ARCHITECTURAL REVIEW BOARD MEETING

TO: Planning and Zoning Commission
DATE: September 26, 2023
APPLICANT: Scott Lewis; *Scott Lewis Homes*
CASE NUMBER: SP2023-031; *Amended Site Plan for 3301 Springer Road*

PROJECT NUMBER: SP2023-031
PROJECT NAME: Amended Site Plan for 3301 Springer Drive
SITE ADDRESS/LOCATIONS: 3301 SPRINGER RD

PROJECT NUMBER: SP2023-032
PROJECT NAME: Site Plan for 855 Whitmore Drive
SITE ADDRESS/LOCATIONS: 855 WHITMORE DR

LANDSCAPE PLAN

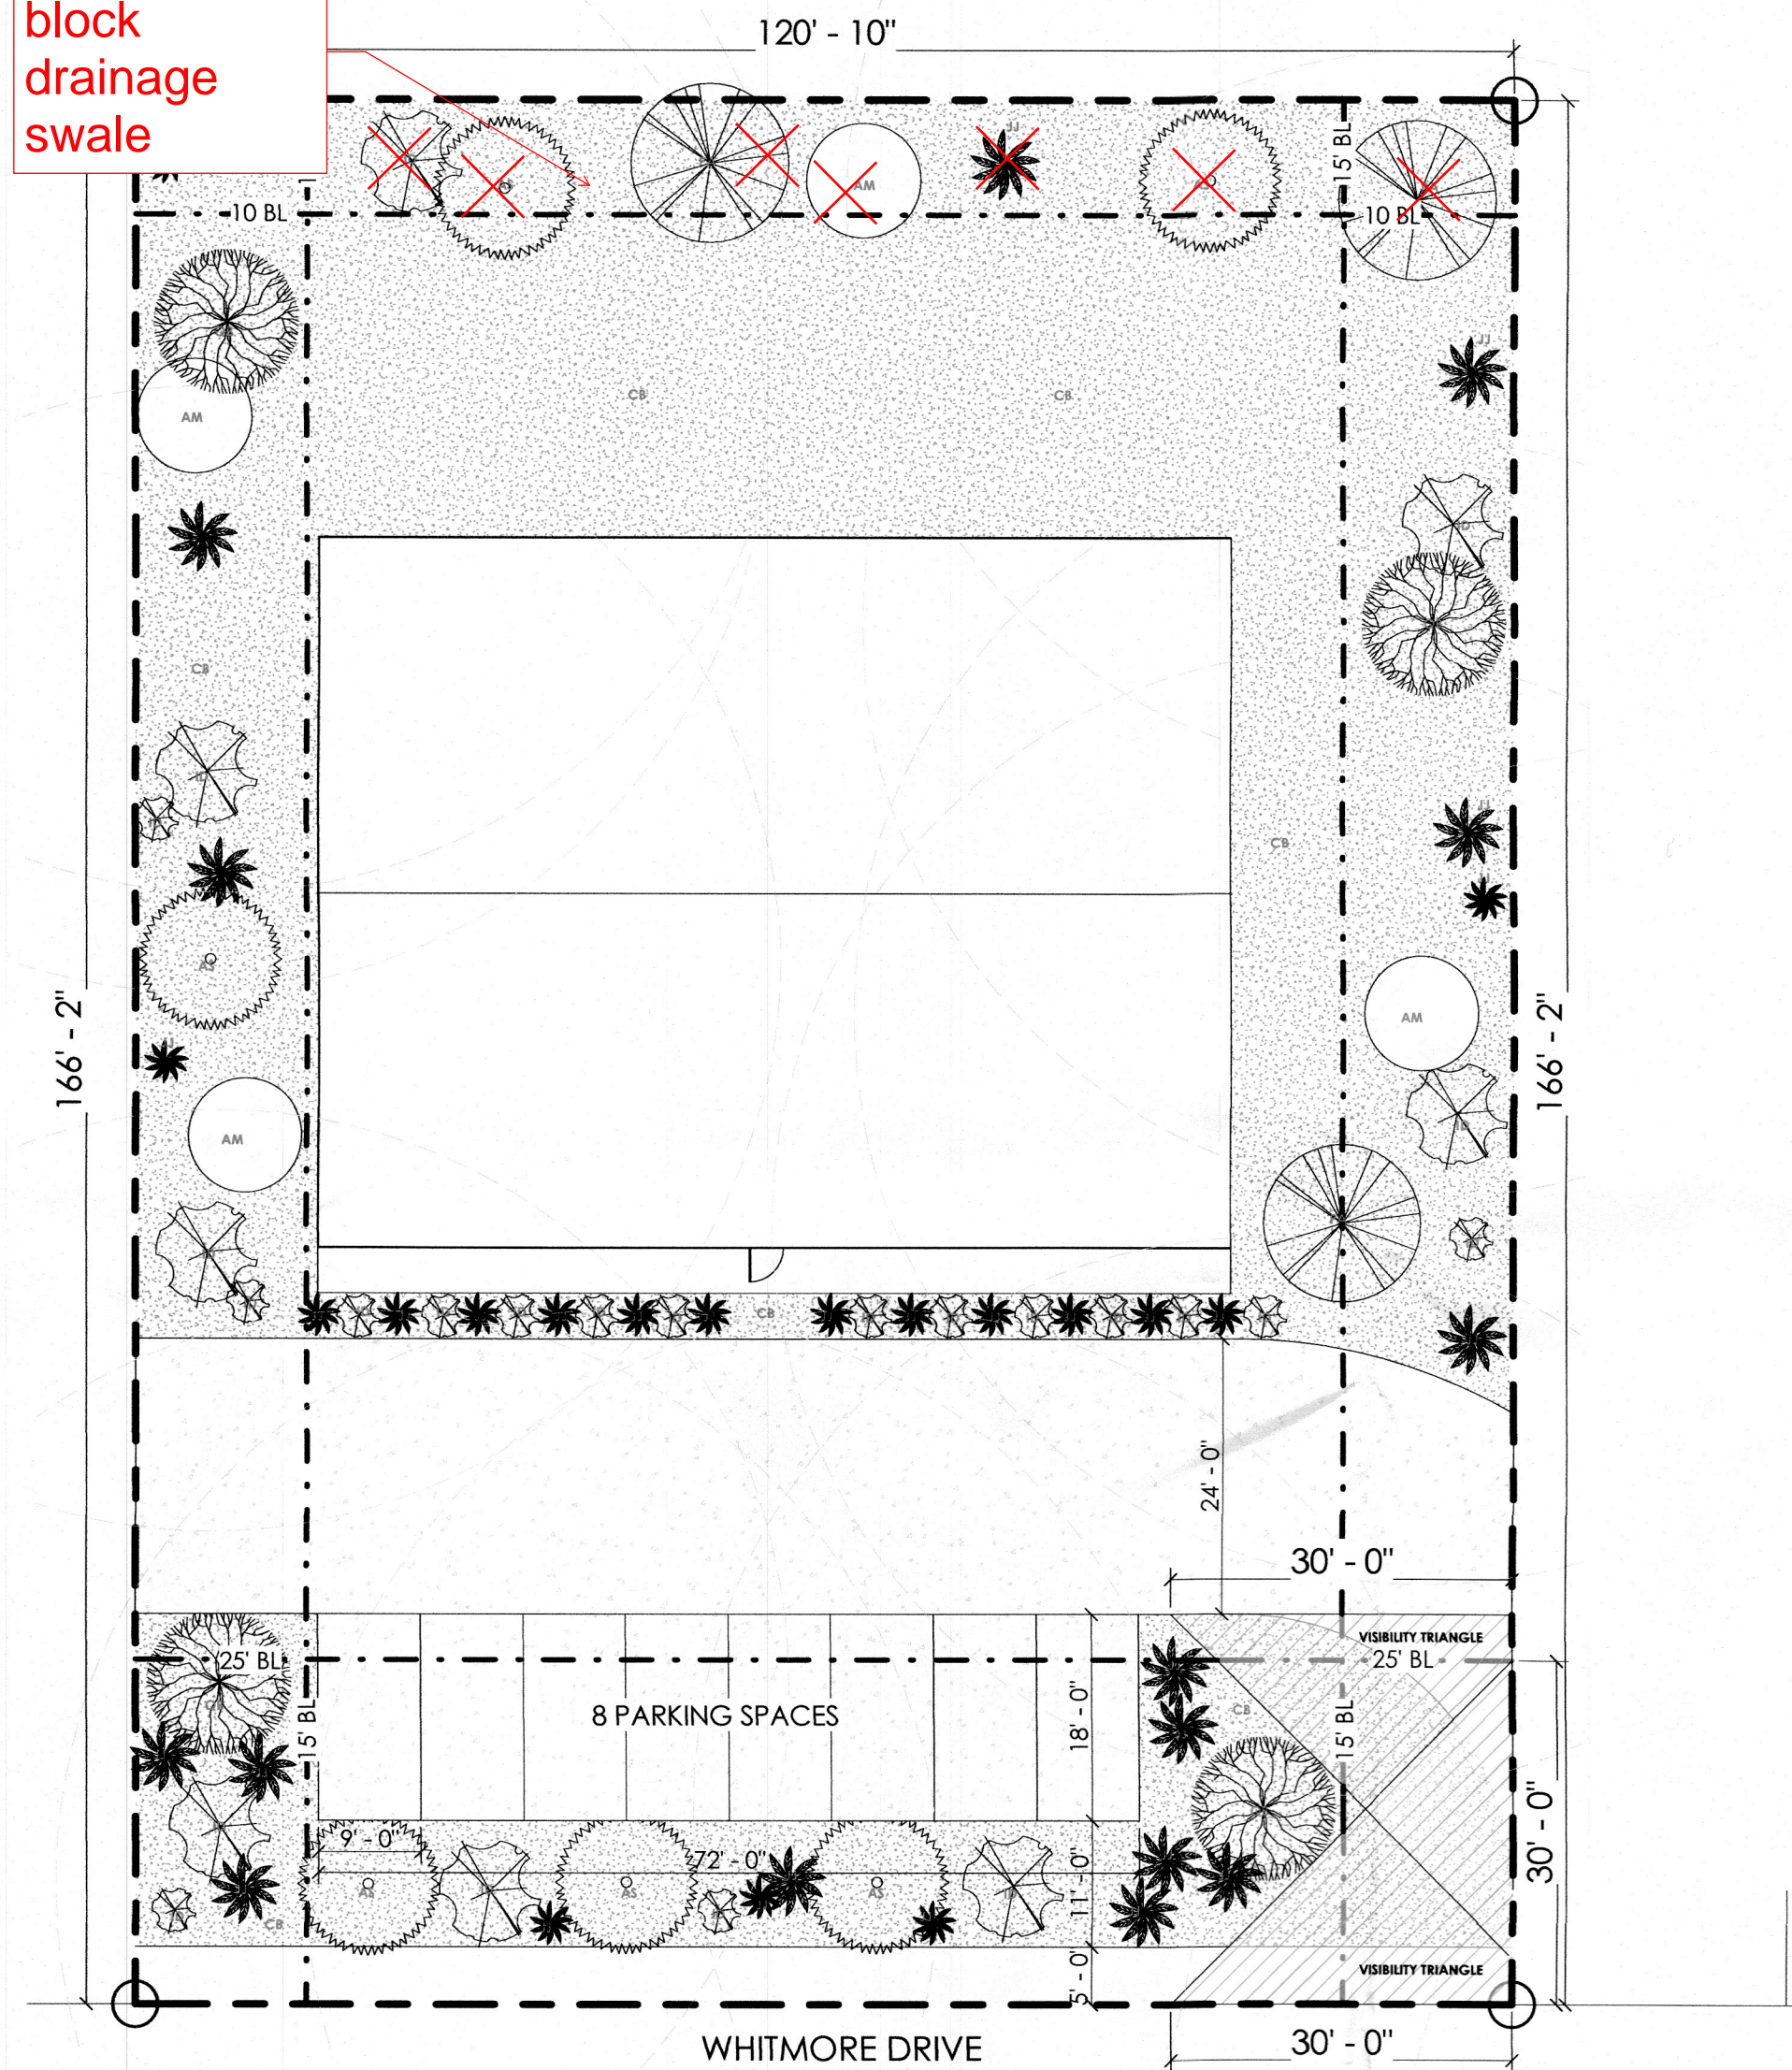
Trees can't block drainage swale
